ADDENDUM NO. 2

RFP #22-53

Valve and Finished Water Tank & Reservoir Improvements

DETAIL OF OVERFLOW
VACUUM BREAKER
Scale: 1" = 1'-0"

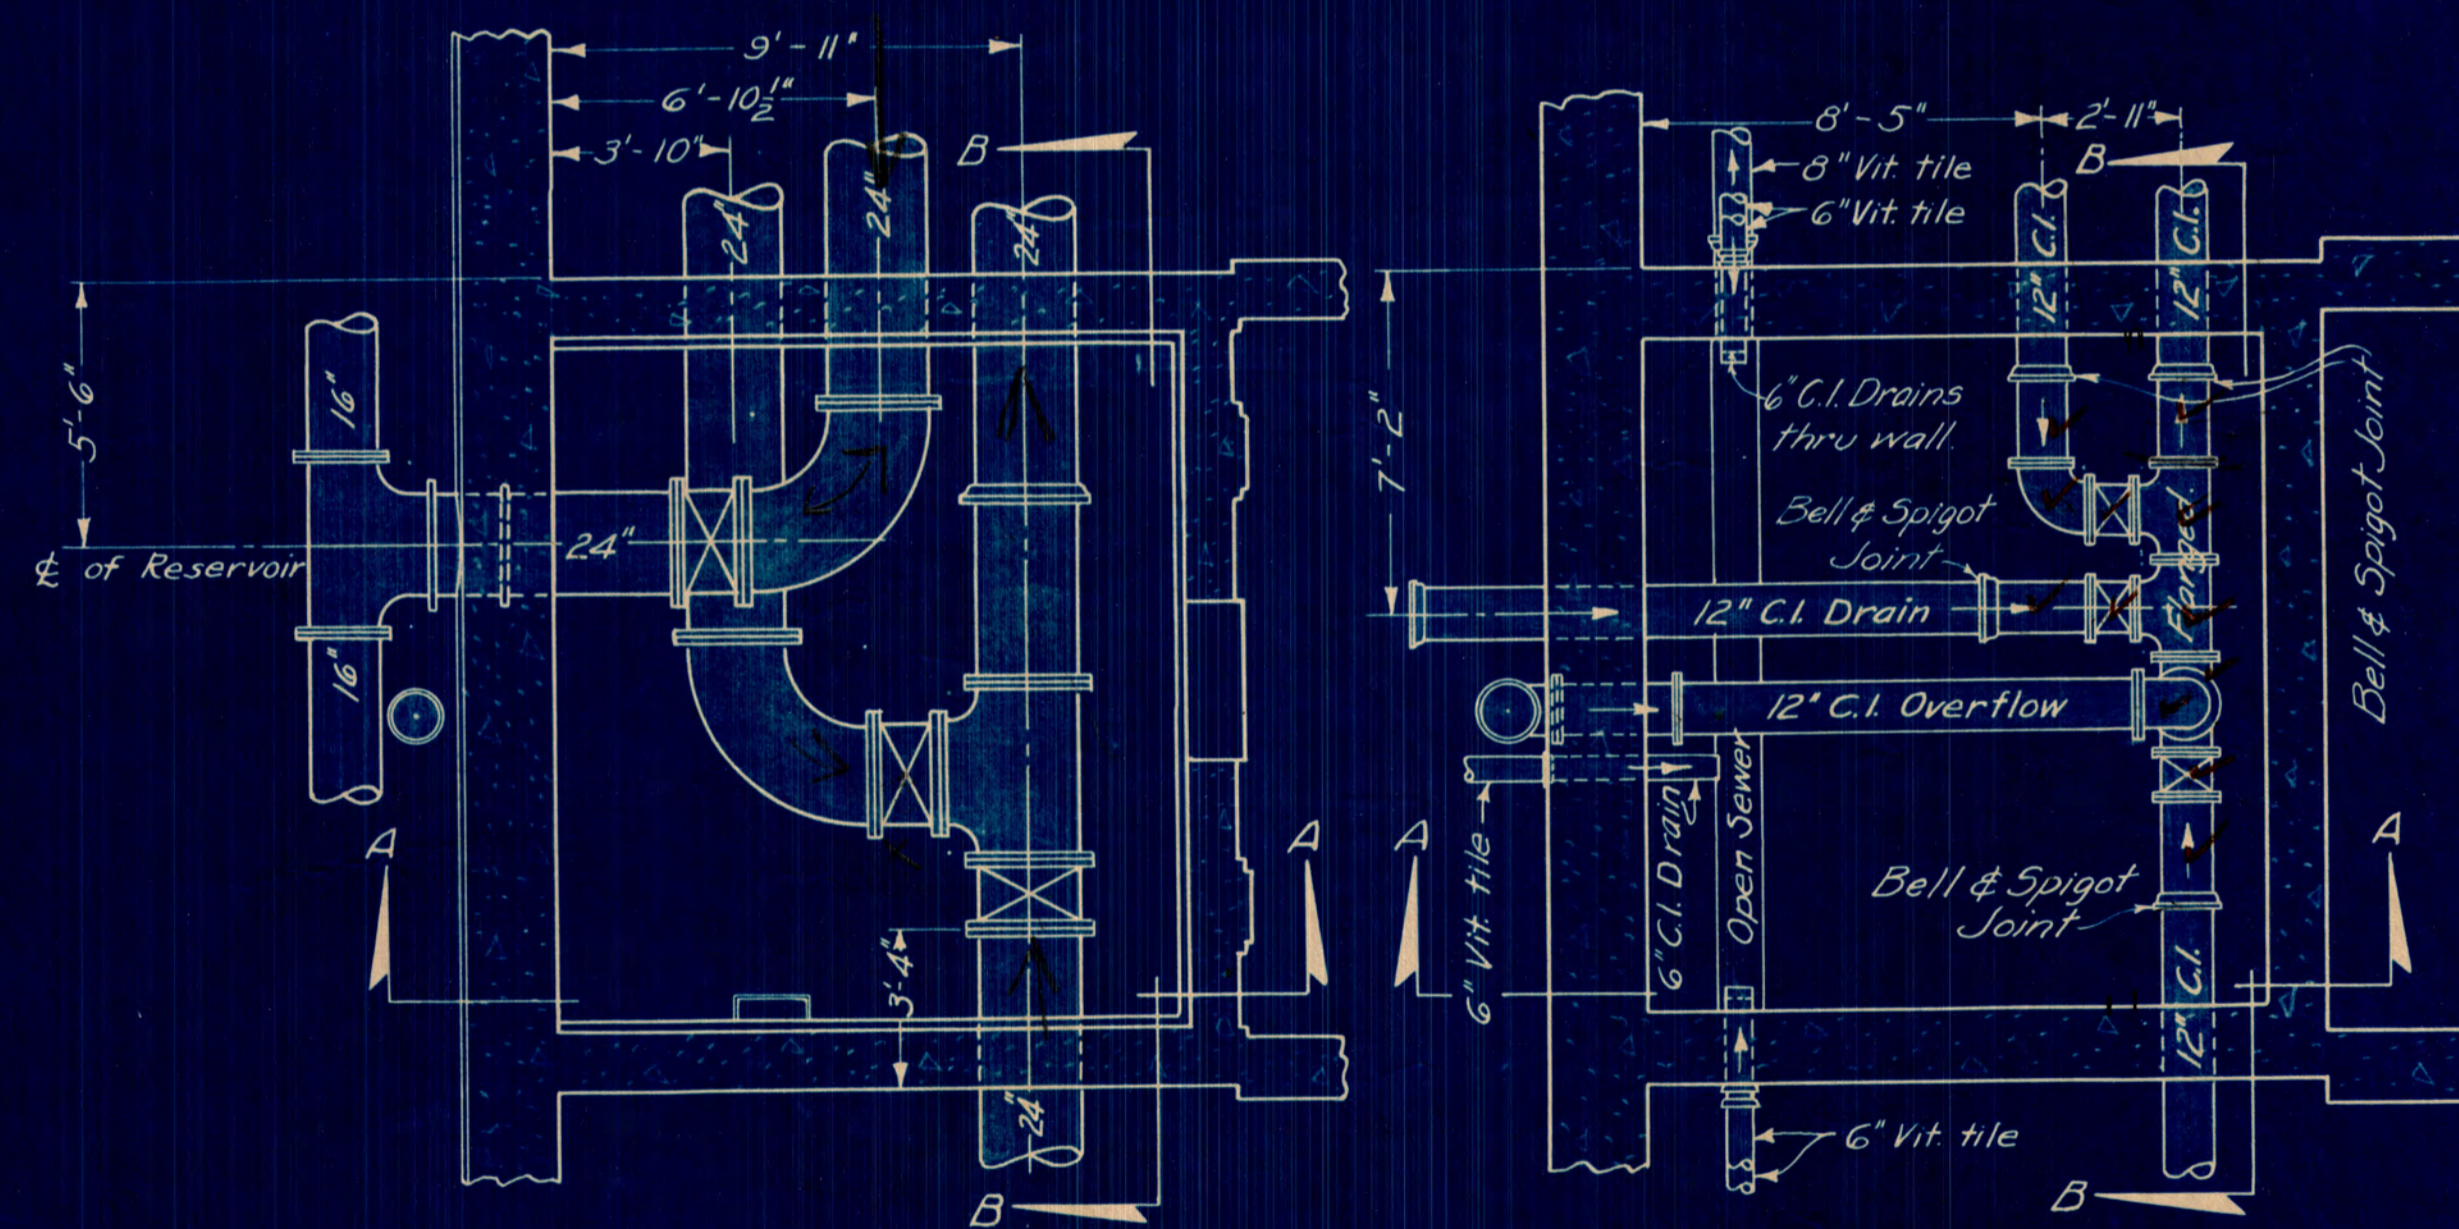
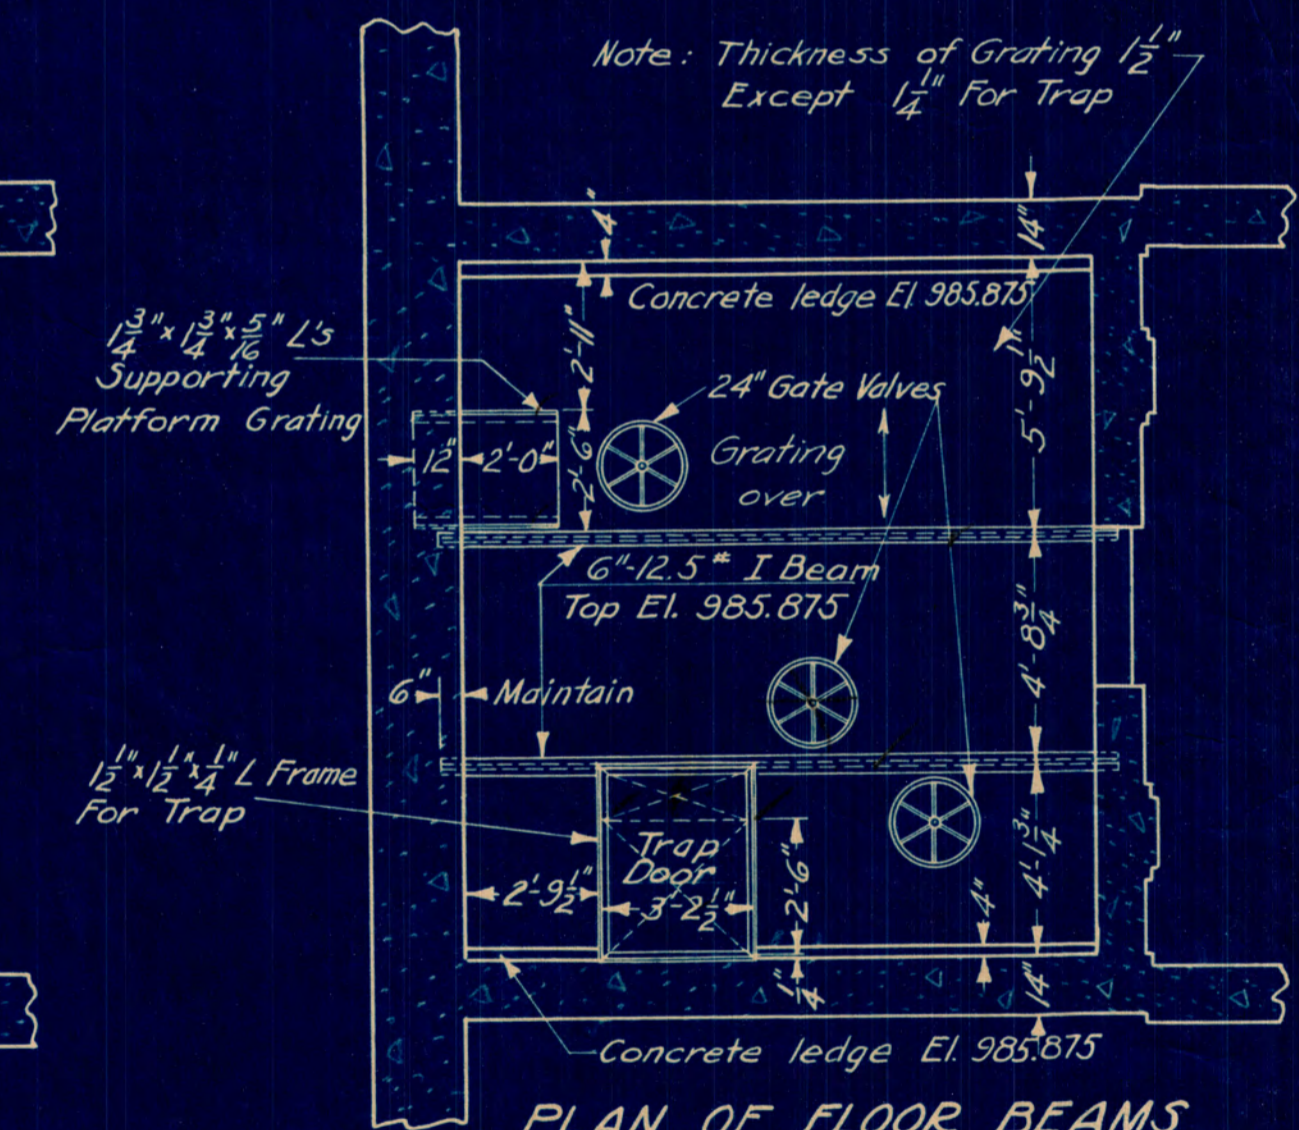
- Q: Notes 3 and 5 on drawing 13 indicates that new supports may be required to support the new grating. Please provide details regarding the existing grating supports so we can evaluate the potential need for additional supports prior to submitting a bid. If new supports are required, will this be considered extra work or incidental to base bid?

- Q: How is the interior of the existing valve vault shown on drawing No. 12 accessed? Drawing No. 12 does not show an opening. What is the size of the Opening and will it support the installation of new grating? Please provide a layout plan and details for the existing Grating supports referenced in note Nos. 3 and 5 shown on drawing Nos. 12 and 13, respectively.
A: See attached record drawings.

- A: See attached record drawing showing existing grating supports in the Vault House. Existing supports should be sufficient, however the age of the structure and lack of a clear condition assessment due to the locations of the supports is uncertain. Repair or replacement of supports would be additional work paid for through the allowance.

SITWORK ELECTRICAL SITE PLAN

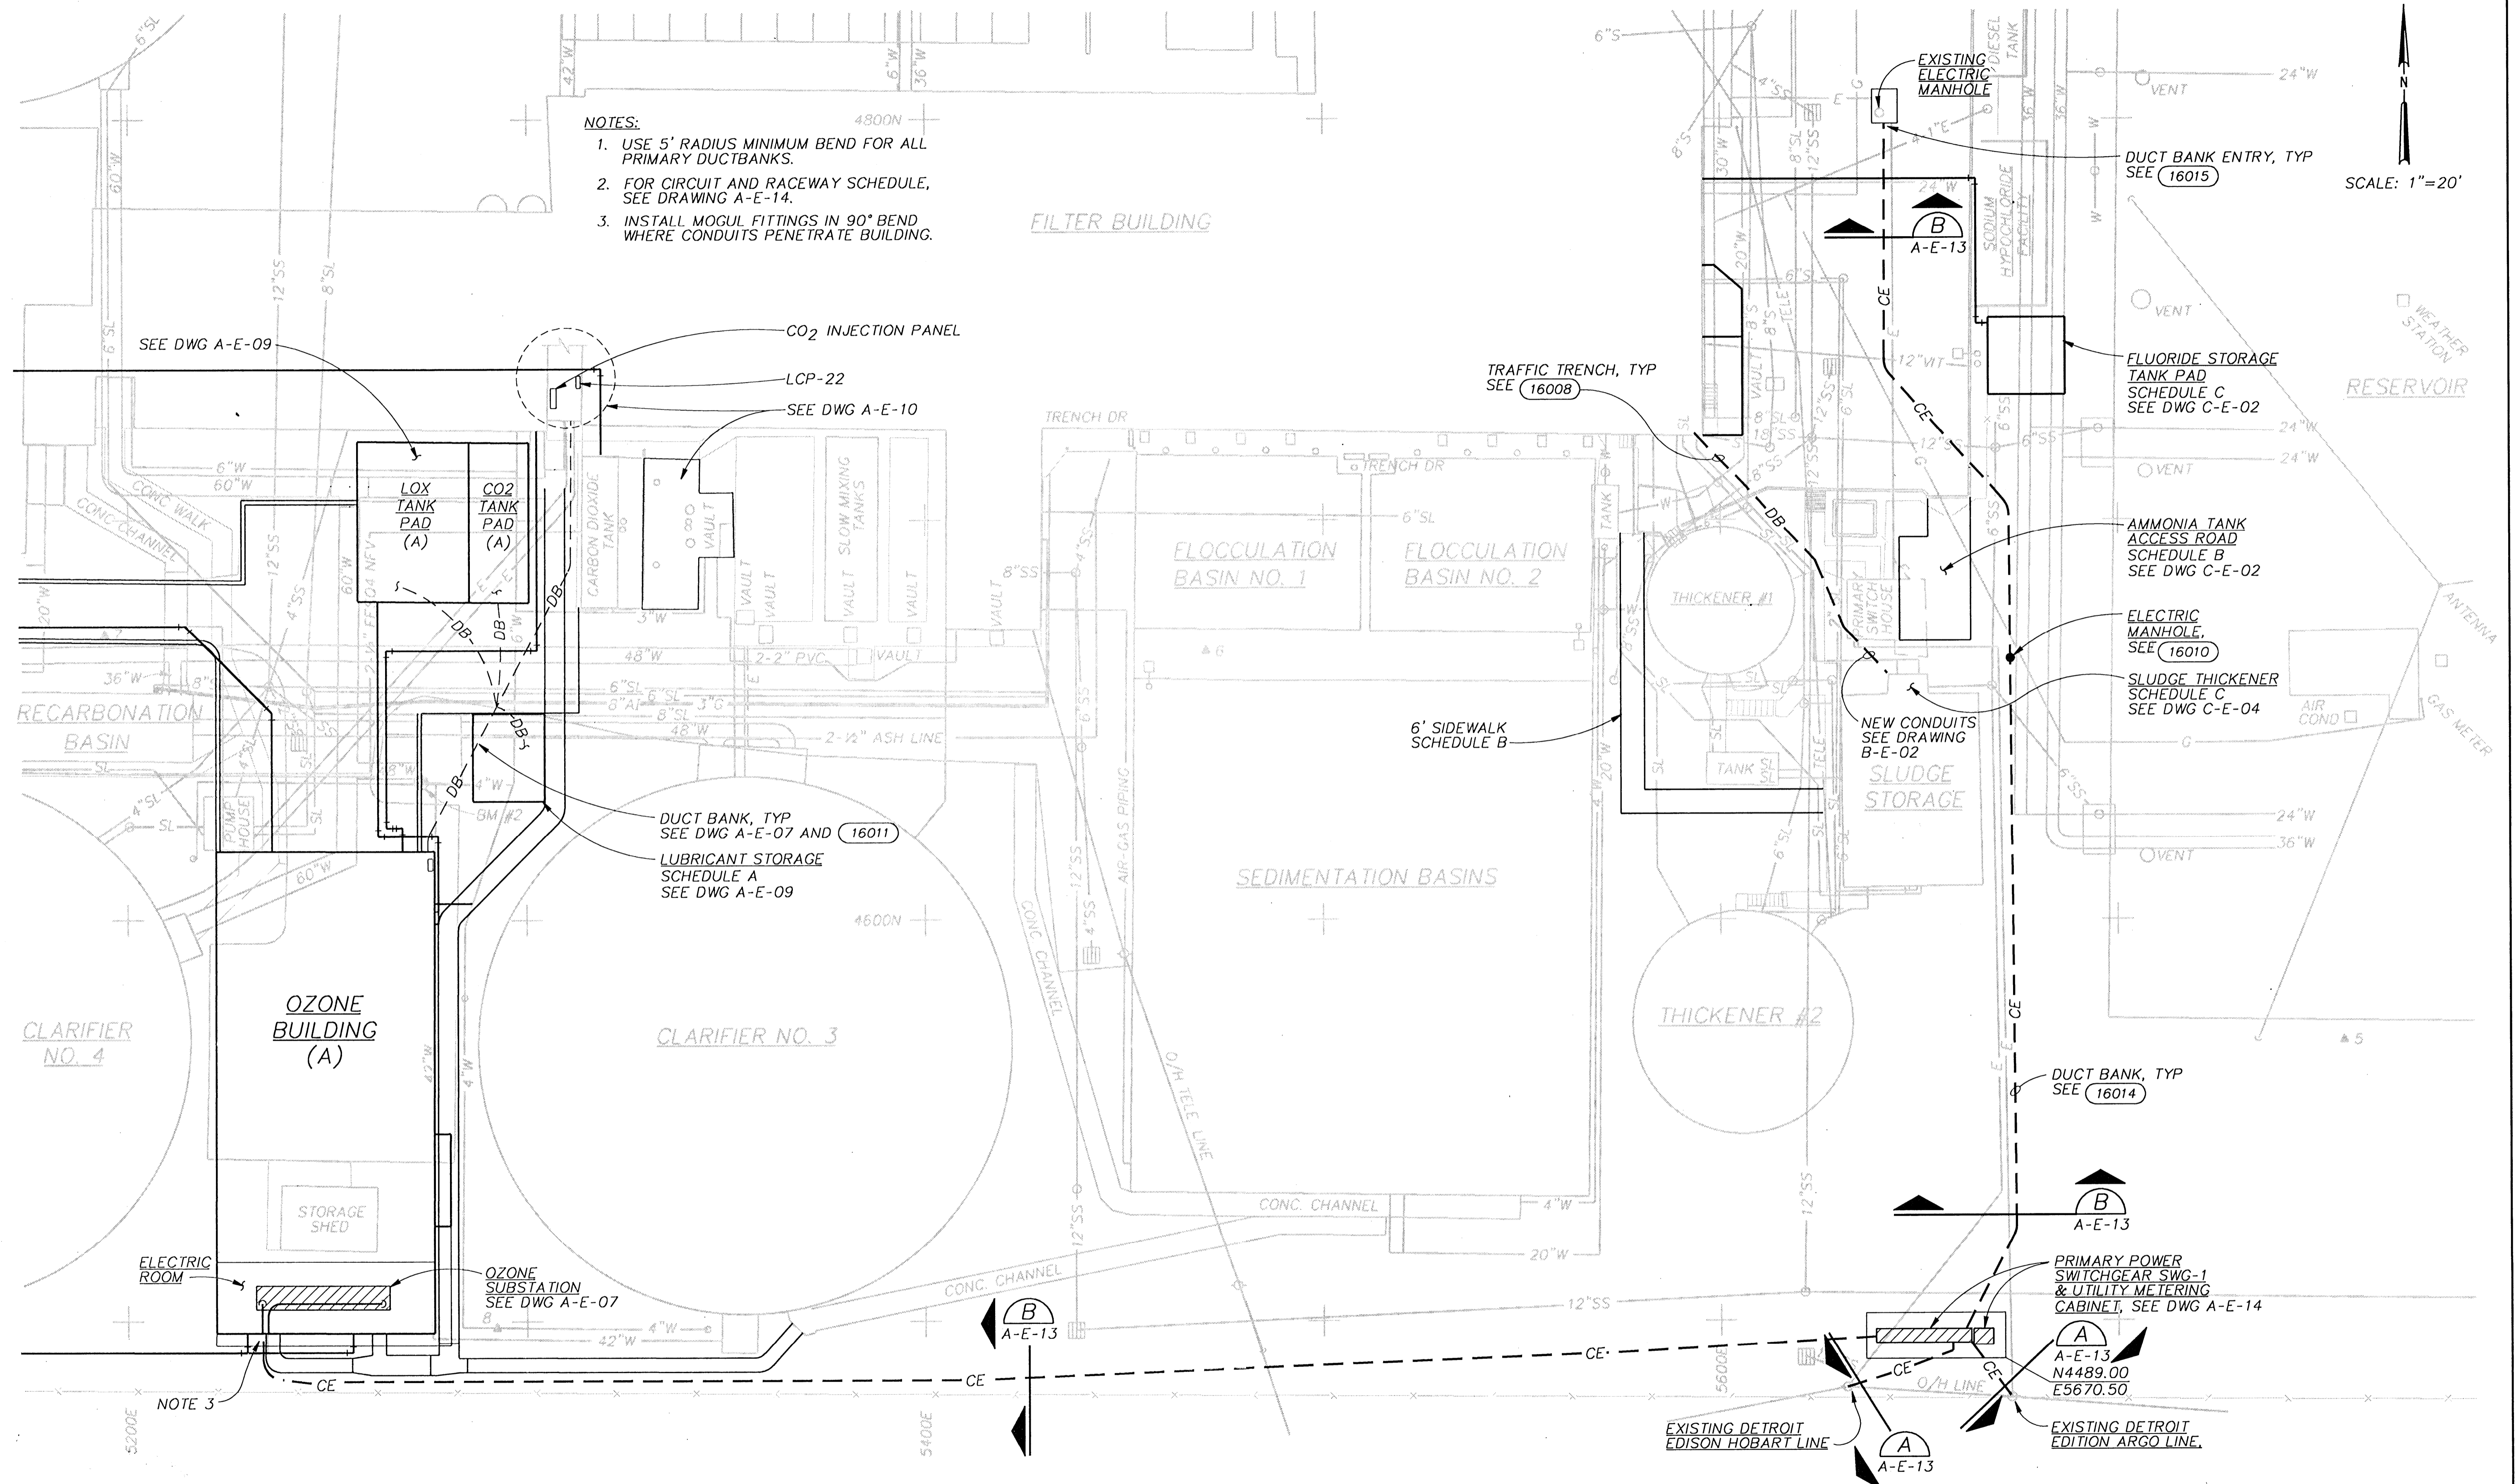
- Q: What is the type, dimensions and burial depth of the electrical duct bank located immediately West of Vault No. 3?
- A: See attached record drawings.

- Q: What is the type, dimensions and burial depth of the electrical duct bank located immediately West of Vault No. 4 as shown on Drawing No. 10?
- A: See attached record drawings.
